ADDENDUM NUMBER THREE

RFQ # 7549344

**TITLE: Freshwater Access Site Improvements, Beach Pond, Exeter, RI,
DEM**

State of Rhode Island
DEM-Planning and Development Contract No. 11-14
Solicitation Number 7549344
Freshwater Access Site Improvements, Beach Pond
Exeter, Rhode Island

Q6) Please refer to Sheet S3 (8 of 12), regarding the proposed steel guide rail.

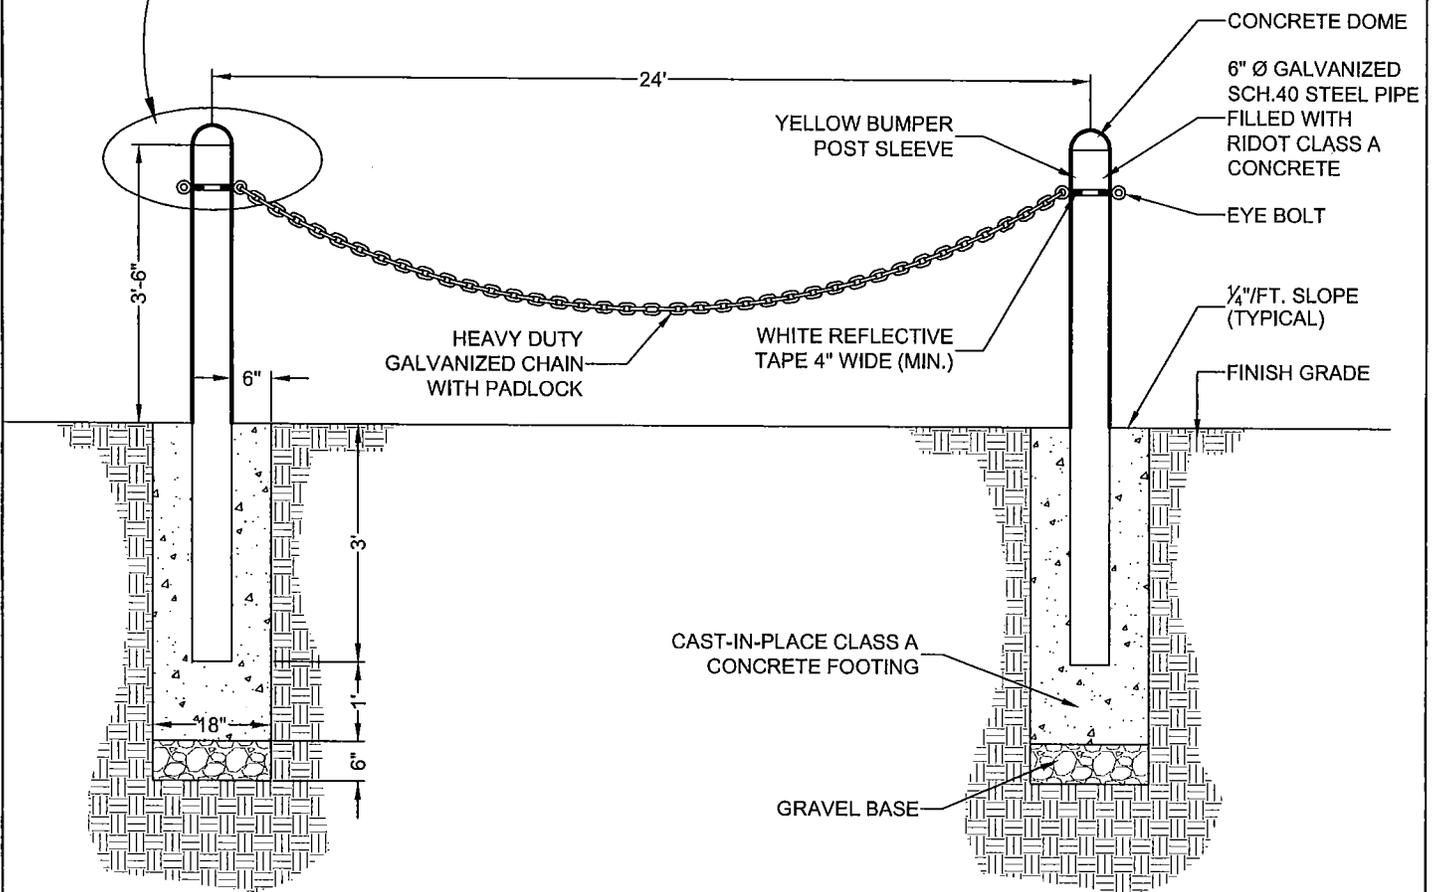
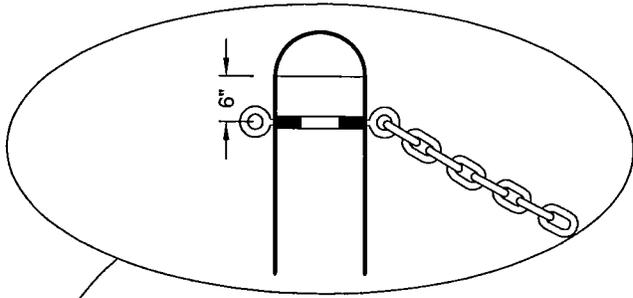
a. Does the guide rail have to be galvanized?

b. The guide rail plan view shows a 3'x2'x1/2" plate (5) per rail. The comprehensive guide rail plan shows 3 per rail. Which is correct?

No

There should be (3) 3' x 2' x 1/2" plates per guide rail, total plates 15.
